CIMARRON CORPORATION

LETTER OF TRANSMITTAL

RE: LICENSE SNM-928; DOCKET 70-0925

LICENSE SNM-928, CONDITION #27(e) CHANGE EVALUATION FORM

Figure 3-1

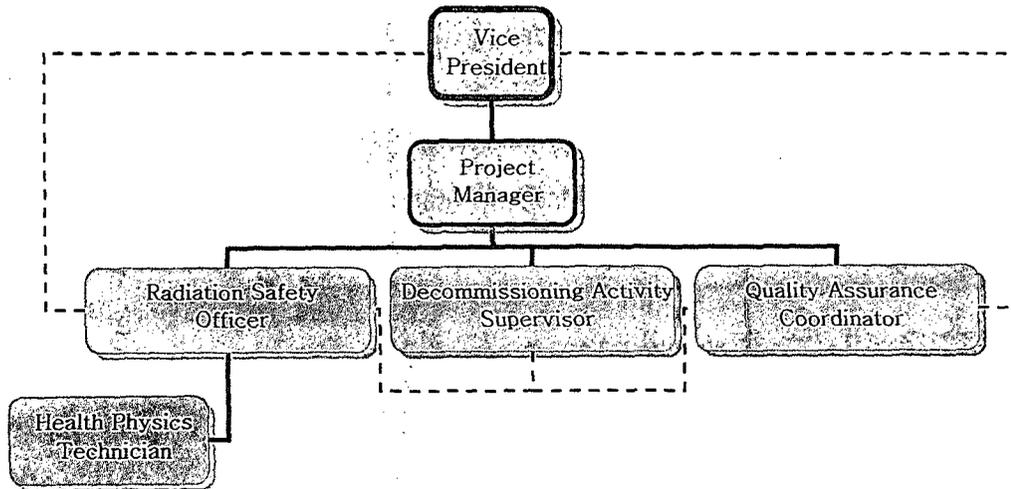
- Revisions to Radiation Protection Plan (Annex A) Sections 03, and 11 thru 16:
 - Section 3 – Administration and Responsibilities
 - Section 3.2 – Radiation Protection Organization – As required in License Amendment #20, the Radiation Safety Officer will be listed by name in the Radiation Protection Plan. Rick Callahan was added to the Radiation Safety Officer section.

Figure 3-1

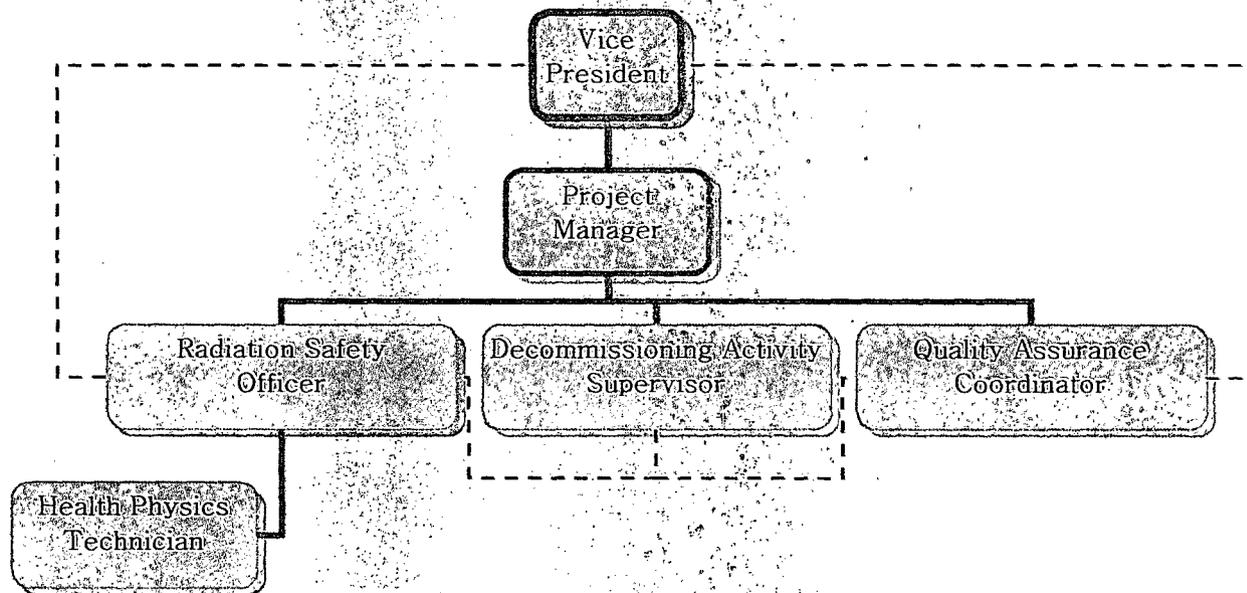
- Section 3.2 – Radiation Protection Organization – Revised the responsibilities of the Vice President and Program Manger to be in line with current activities.
Revised Individual Worker statement to “complying with regulatory requirements and applicable radiation protection procedures”
